Department of Environment and Science

EA0001401 – Hopelands Groundwater  
Technical Assessment

18 March 2021 - FINAL

**Figure 7 Groundwater heads and flow directions (arrows) based on observed versus calibrated steady-state model heads**

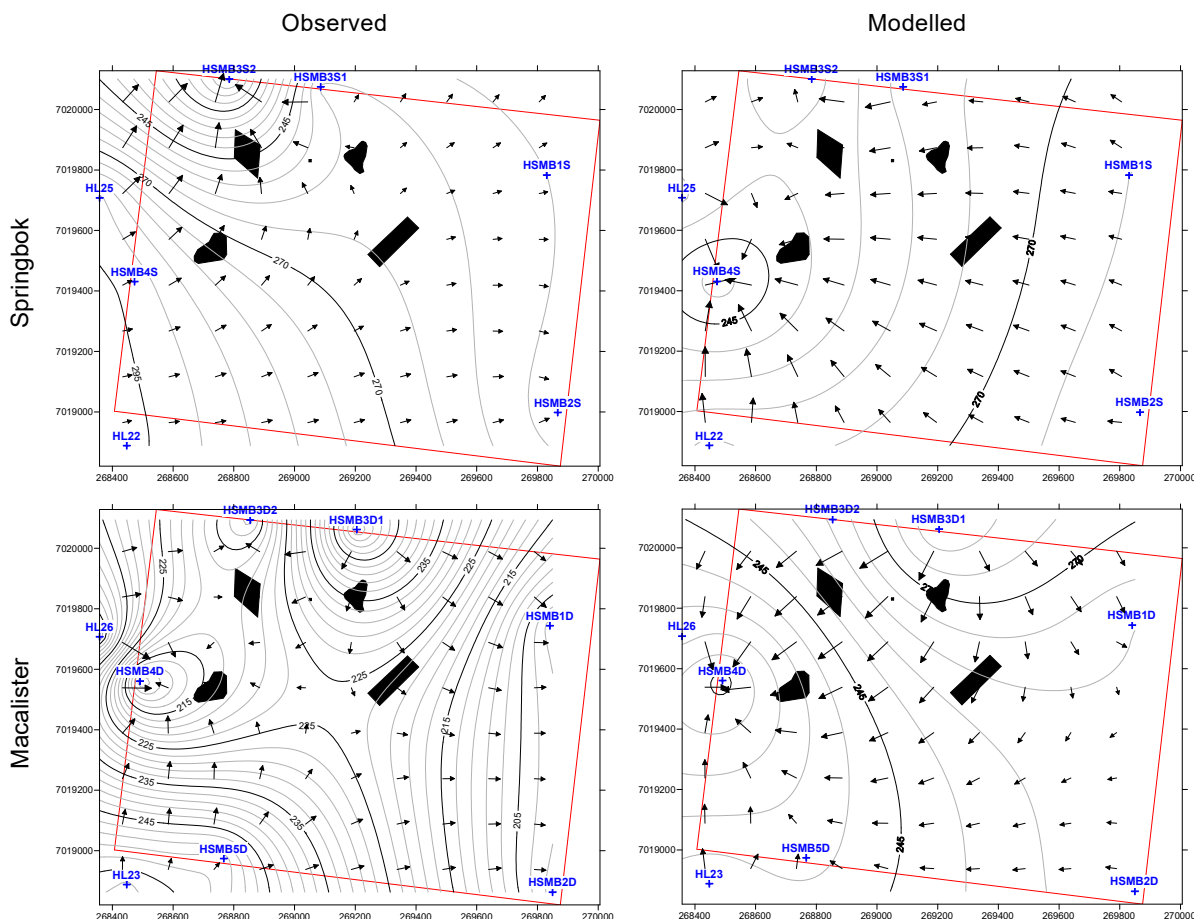
AGE (2020) tabulated the measured versus modelled hydraulic heads for the calibrated steady state model for the DES HSMB<sup>6</sup> bores and the Arrow HL bores. The comparison shows differences of up to roughly 60m. AGE suggested that these differences may be due to lack of coal connectivity or lower hydraulic conductivity values than what is incorporated in the calibrated model. To understand the implications of these hydraulic head differences, the data have been contoured<sup>7</sup>, plotted spatially and presented as Figure 7.

The map based on the observed data for the Macalister seam shows a generally inward flow direction between the gasifiers, but with easterly flow (offsite) to the east of the gasifiers. In comparison, the modelled data show a westerly flow from the eastern site boundary (onsite). Both sets of data identify HSMB4D to be the lowest pressure and hence groundwater should flow towards it. The observed data shows a much higher pressure in HL26 (~45m) further to the west, thus limiting the potential for significant westward groundwater flow. A similar trend is seen in the

modelled heads, but with a lesser head difference. Within the Macalister seam, the implications of the differences between the observed and modelled heads may be:

- Understating the potential for offsite contaminant migration to the east of the site. The boundary of Lot 40 Plan DY85 is over 2,000m from the assumed extent of the closest gasifier.
- Overstating the potential for offsite contaminant migration to the west of the site.

With regards to the Springbok Sandstone, the observed heads show groundwater flow potential to the east, with localised flow potential toward HSMB3S2 on the northeast boundary of the site. The modelled heads show primarily westward flow, with only minor flow potential towards the northeast. Both the observed and modelled heads show a potential for off-site movement to the north in the northwestern corner of the site. DES has recently installed an additional monitoring bore in this direction, but the data has not yet been collected (pers. Comm. DES, 2021). The model is likely to overstate the potential for offsite migration to the west – in the direction of development.

The complexity of the contours and the extremely high observed hydraulic gradients are suggestive of some degree of hydraulic disconnection across the site. This cannot be quantified with the data available to Arrow. It does, however, suggest that fracturing cannot be pervasive or sub-regionally extensive, as the increased bulk hydraulic conductivity due to pervasive fracturing would lead to flatter hydraulic gradients and more consistency in flow directions.

**Figure 9 MLU model predictions for the Springbok Sandstone drawdown for various Kv's of the Upper Macalister interburden**

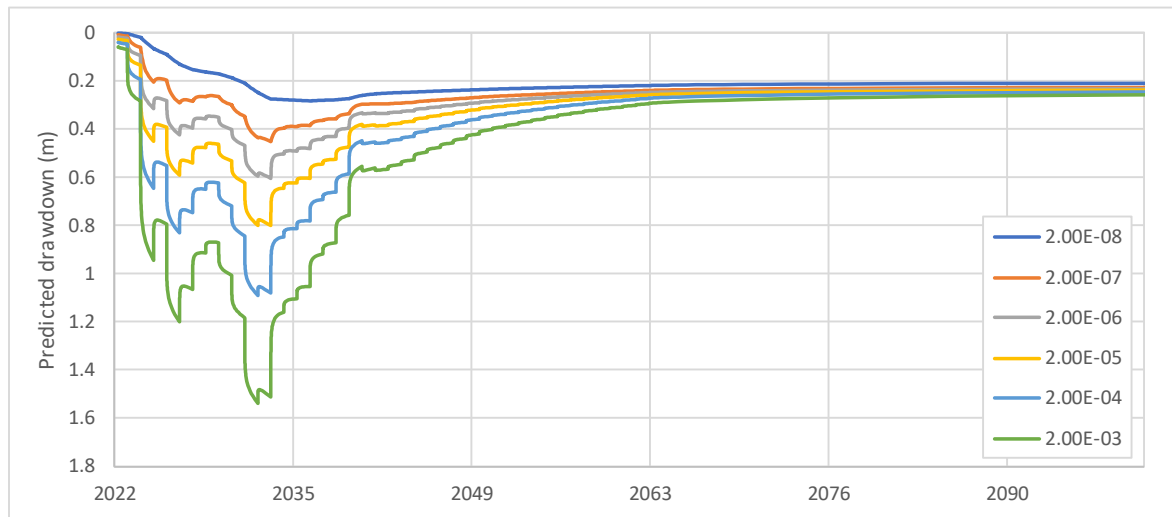
The model predictions are shown on Figure 9, and despite the highly conservative model assumptions, show a maximum predicted drawdown of roughly 1.5 m. The upper limit of the Kv assessed is the same order of magnitude as the horizontal hydraulic conductivity of the coals and is unrealistically high.

In conclusion, the very low Kv's used by AGE (2020) are unlikely to significantly affect the predicted drawdown in the Springbok Sandstone and thus will not result in unduly optimistic estimates of contaminant transport distances in that formation.

**Figure 10 Analytical transport model predictions: Macalister seam – FDP approximation, Scenario A, Scenario B and Scenario C**

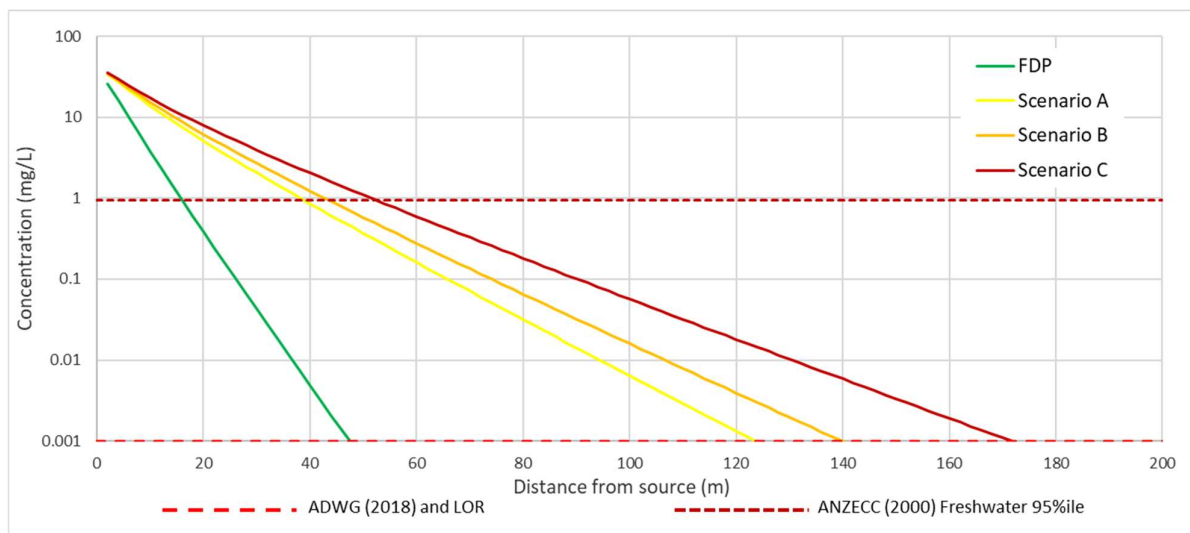
Figure 10 shows the result of the step-wise increase in the model parameters which result in an extreme-case scenario where predicted contamination transport distances are maximised despite the physical inconsistencies in the model as discussed above. In comparison to Arrow's worst-case scenario (FDP Approximation), increasing the hydraulic conductivity and hydraulic gradient to the maxima of Arrow's reported ranges and reducing the porosity to that used by the wider CSG industry, the maximum predicted distance for contaminant transport was less than 180m after 100 years (as compared to Arrow's assessment of 20 years). While this is four times greater, it is highly conservative and suggests that Arrow's predicted contaminant transport distances are not unreasonable. The shortest distance from the gasifiers to the site boundary is roughly 200m.

**Figure 11 Analytical transport model predictions: Springbok Sandstone – Scenario D**

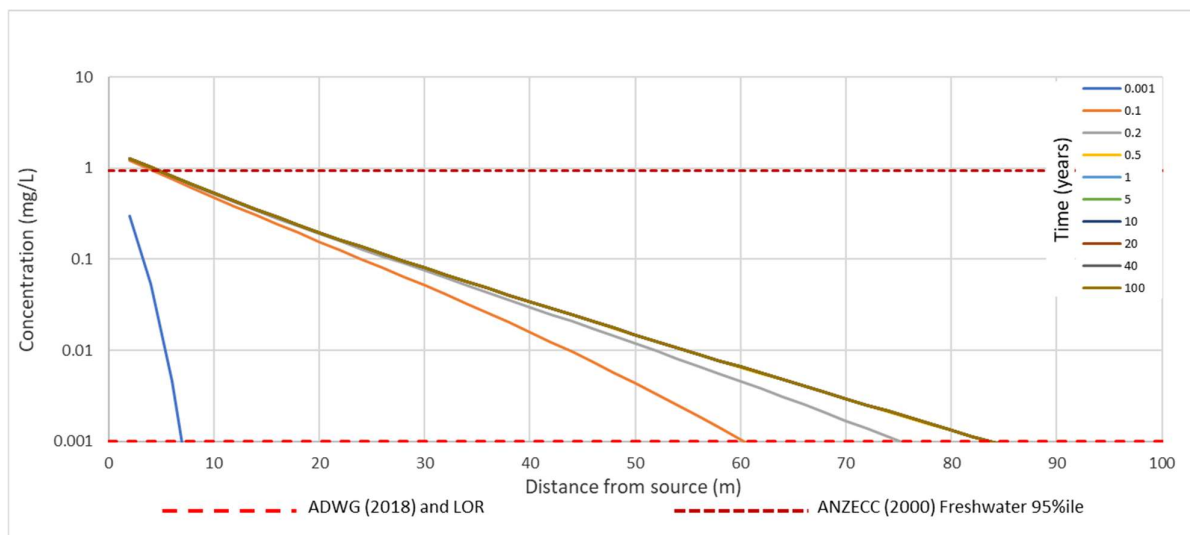
For the Springbok Sandstone (Figure 11), this conservative assessment indicates a maximum transport distance of less than 90m, which is less than twice the maximum distance predicted by AGE (2020).

**Figure 13 Conceptual model of fugitive gas migration (not realistic, not to scale)**

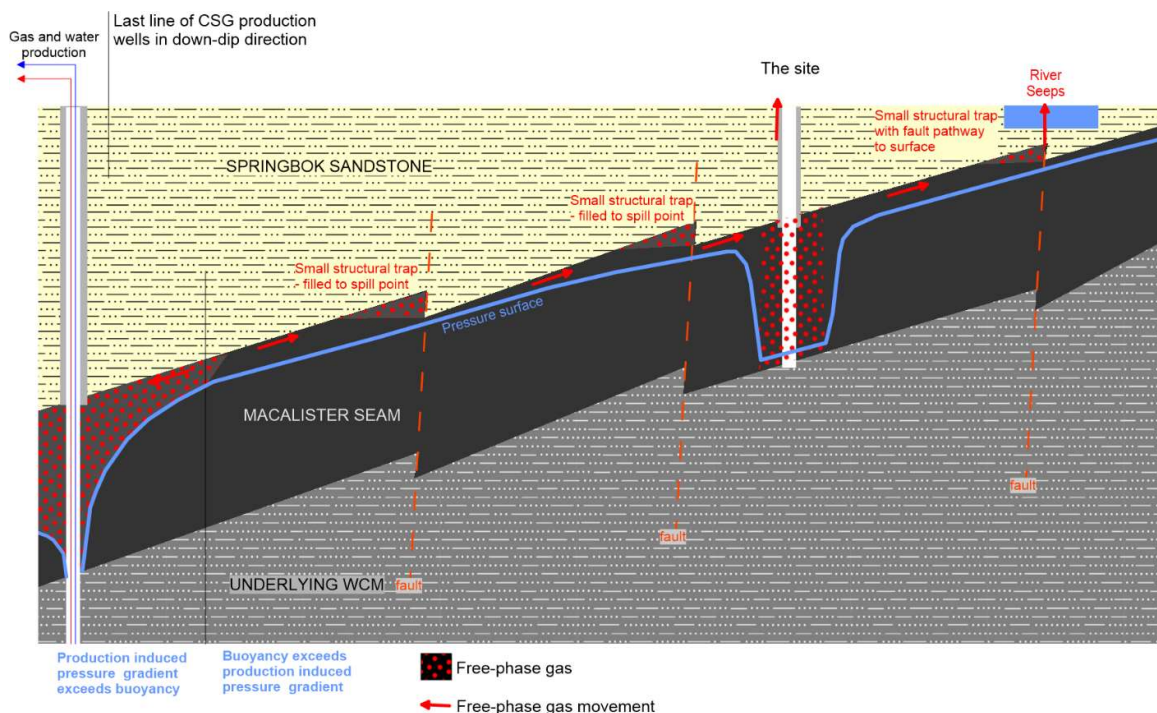
It is highlighted that the discussion that follows regarding fugitive gas migration is highly conceptual, and the associated risks cannot be quantified. A schematic diagram is provided as Figure 13 to assist with the description.

- If fugitive gas from Arrow's development migrated through the site, and the gas did not escape or get trapped within the site boundary, it is possible that the migrated gas could "sweep" contaminants off-site in the updip direction (nominally to the northeast). It is also possible that fugitive gas has migrated up dip from the site historically due to Linc's former activities. If encountered via drilling, it may not be possible to distinguish the differences between a contaminated gas pocket derived directly from Linc's activities and one that may have accumulated through fugitive migration and contaminant sweep from Arrow's activities.

Because of the lower permeability and reduced fracture density compared with the Undulla Nose, the potential for fugitive gas to migrate from is considered to be significantly lower than in the vicinity of the Condamine Bubbles. If gas did migrate to the site from downdip:

- Assuming the legacy wells are not yet decommissioned, there may be some additional fugitive emissions from the site via wells with poor integrity providing vertical pathways to the atmosphere. Gas may also escape from ground fractured during the overpressure event(s) and/or cavity collapse. This gas could possibly "sweep" volatile contaminants resulting in contaminant emissions to the atmosphere.
- Since induced fracturing has only been observed in the Macalister seam in the direction from which gas would migrate, the induced fractures are more likely to act as a gathering network to bring fugitive gas to the site, rather than enhance off-site gas migration.
- The continued maintenance of low pressure across the site (either via active extraction, or fugitive emissions) relative to its surrounds will minimise the potential for buoyant migration away from the site.
